Derby Diocesan Association of Church Bellringers Consultant's Report	Report No. DDACB 06/05
Inspection Of Bell Installation at St James' Church, Whitfield Parish, GLOSSOP	Issue Date 10/06/05

FIGURE 1
Ringing Room

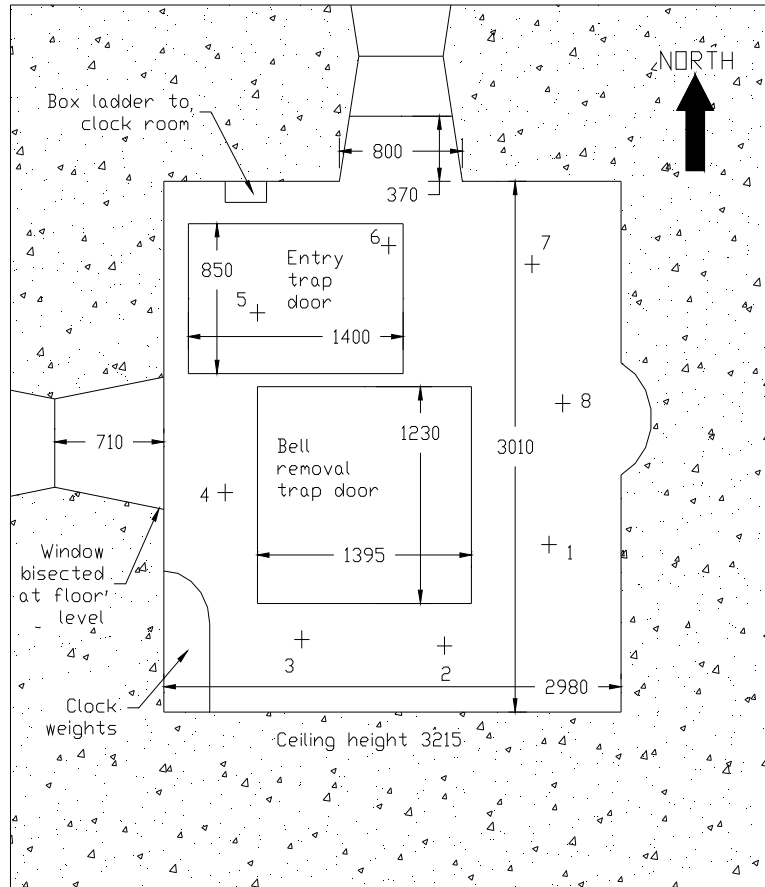
The ringing room is reached by climbing a wide staircase. At the top of the stone step section is a cabinet containing the Ellacombe chiming mechanism. A set of wooden steps then leads to a large padlocked wooden trapdoor. This is counterbalanced and held open by a simple catch which is attached to one side of the vertical wooden ladder.

The room is almost square in section with plastered walls and there is plenty natural light from the floor level windows fitted into the North and West walls. The ringing floor bisects these windows and whilst the floor has been extended into the North facing window recess this is not the case with the west facing window and a gap of 750mm X 710mm is present. Further natural light is supplied by windows on the North, East, and West aspects which are bisected by the clock room floor.

The eight ropes fall in a good circle with the normal ringing position for both Bell No. 5 and Bell No. 6 being on the closed trapdoor position. The eight ropes for operating the Ellacombe chimes are neatly arranged in the North East corner adjacent to the ringing position for Bell No 7.

Almost centrally placed in the wooden floor is a large bell removal trapdoor.

A 48mm diameter steel strut to support the clock mechanism is fixed into the North Wall which in no way interferes with the ringing of any of the bells. The ceiling is supported on two Reinforced Steel Joists (RSJ) running North - South and two RSJ's close to the South wall running East - West. It is 3.215 metres from the floor which is safe in the event of a ringer being carried up following the breakage of a stay. A rectangular box containing the clock pendulum hangs down from the ceiling to which a single light is fitted. The clock weights are enclosed in a wooden cabinet located in the South West corner.

1. Replace the single filament bulbs fitted in the ringing room and the clock room by double fluorescent fittings. It is suggested that two double fluorescent fittings are fitted in the bell chamber. One to illuminate the area where the lower bells are hung and another to illuminate the higher level.
2. Bell No. 1 - slacken off crown staple nut and retighten making sure that the clapper is striking the sound bow in the centre of the worn section.
3. Bell No. 2 - a. tighten both bolts holding stay in place.
b. grease spindle on double pulley. (bell chamber)
Note If any stays have to be replaced after breakage then use stays made out of ash.
4. Bell No. 3 - grease spindle on pulley. (bell chamber)
5. Bell No. 4 - a. replace double pulley with new unit. (bell chamber)
b. fit new grease caps to bearings.

FIGURE 2
Clock Room

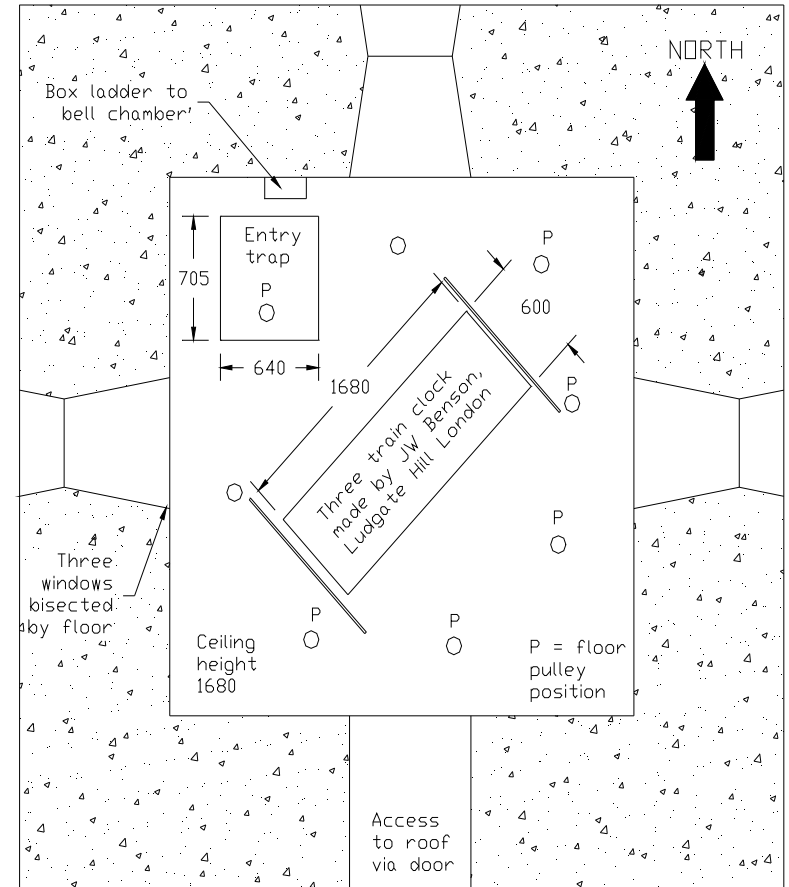
The clock room is reached by climbing the vertical box section ladder and opening the counterbalanced trapdoor which rests back against the wall. On the clock room side of this trapdoor is fitted a single pulley through which runs the rope for Bell No 5.

Note no attempt should be made to open the trapdoor when Bell No. 5 is in the raised position.

The area is dominated by the clock mechanism which is mounted centrally on a wooden frame running North East - South West. It was manufactured by J.W. Benson of Ludgate Hill, London and the manual winding positions are located on the South East side which is furthest away from the trapdoor. At present the clock is not operational and it's position completely blocks any exit route for removal of the bells internally within the tower. The floor is of wooden plank construction approximately three inches thick. The low ceiling (1.68 metres) to which are fitted several bell cranks for the clock chiming, is of tongue and grooved wooden construction. In the South West corner of which, there were serious signs of wet rot. There is a single light fitted to the West Wall and the area was clean and bird free. The ropes pass through the room all in boxes or flapper boards apart from the fifth. Pulleys are fitted at both floor and ceiling level on Bell No's 1,2,3,5,7,& 8.

No 7 rope - needs greasing but serviceable.

Ceiling pulley - grooved and needs greasing and new grease cap. Serviceable.

10. Monitor wheel segments at six monthly intervals.
11. Bell No. 7 - a. grease spindle on both floor and ceiling mounted pulleys. (clock room)
b. fit new grease cap.

FIGURE 3
Bell Chamber
Lower Bell Frame

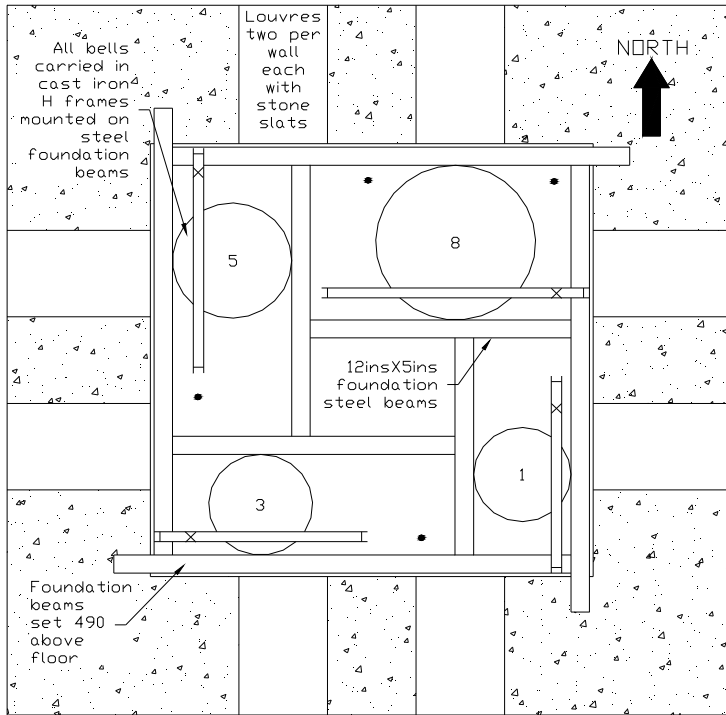
Bells 1,3,5, and 8 are carried in a cast iron H frame which is mounted on four steel foundation beams which are keyed into the wall as shown in figure 3. The foundation beam running along the North wall is further supported by 3 stone corbels. The foundation beams (12 ins x 5 ins) are mounted 490mm above the wooden floor which makes moving around under the bells possible but one has to take care in avoiding the extra ropes and metal rods associated with operating the Ellacombe and clock chiming.

Although of adequate size and showing little sign of corrosion it is recommended that the beams should be either wire brushed by hand, and for particularly bad areas an angle grinder fitted with a wire cup brush should be used. The use of eye and ear protection is essential when undertaking this task. Also a watchful eye should be kept out for the fire hazard. Where bare metal is reached a three coat paint application should be applied as follows -

The H type cast iron frame (2metres) high, mounted on the foundation beams, should be treated as per the foundation beams with particular attention being paid to the fixing bolts.

- Red Oxide primer
- Grey undercoat
- Gloss top coat

If only surface rust is removed then a good undercoating followed by the gloss coat will suffice.

b. replace missing 'dingler'.
9. All the metalwork in the bell chamber should be wire brushed, bolts checked for tightness, and then painted with red oxide paint followed by an undercoat and gloss topcoat.

FIGURE 4
Bell Chamber
Upper Bell Frame

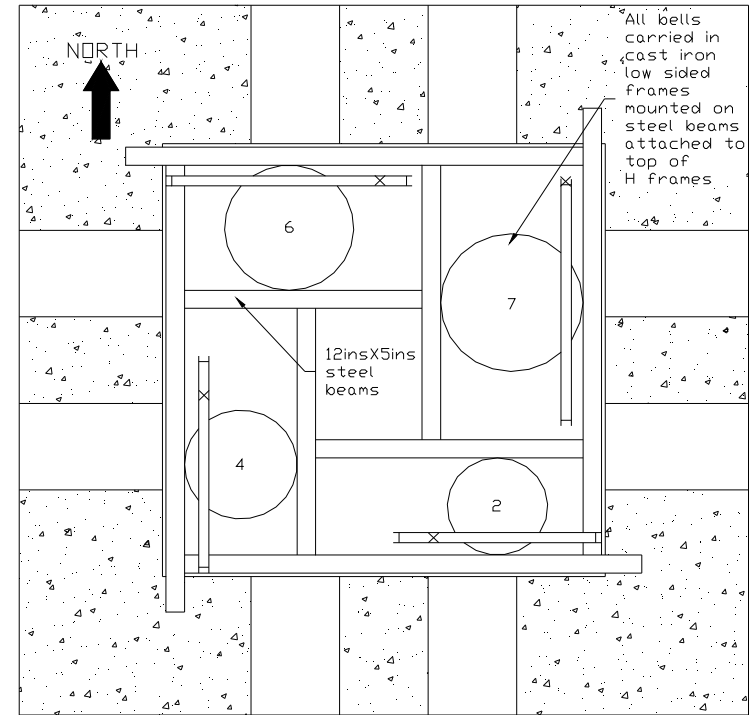
Bells 2,4,6, & 7 are carried in the upper frame which is mounted on four reinforced steel joists which are keyed into the wall as shown in figure 4 and supported at each corner by a stone corbel. These joists are bolted to the top of the H frame making a very solid and stable configuration. Inspecting and undertaking any repairs to these bells and fittings is extremely difficult and great care must be taken, not only in reaching the upper level but also when working there. The foundation beams and lowside frame, although of substantial dimensions, showed signs of neglect and the rust removal and paint treatment as specified for the lower level should be carried out with particular attention being paid to the holding bolts.
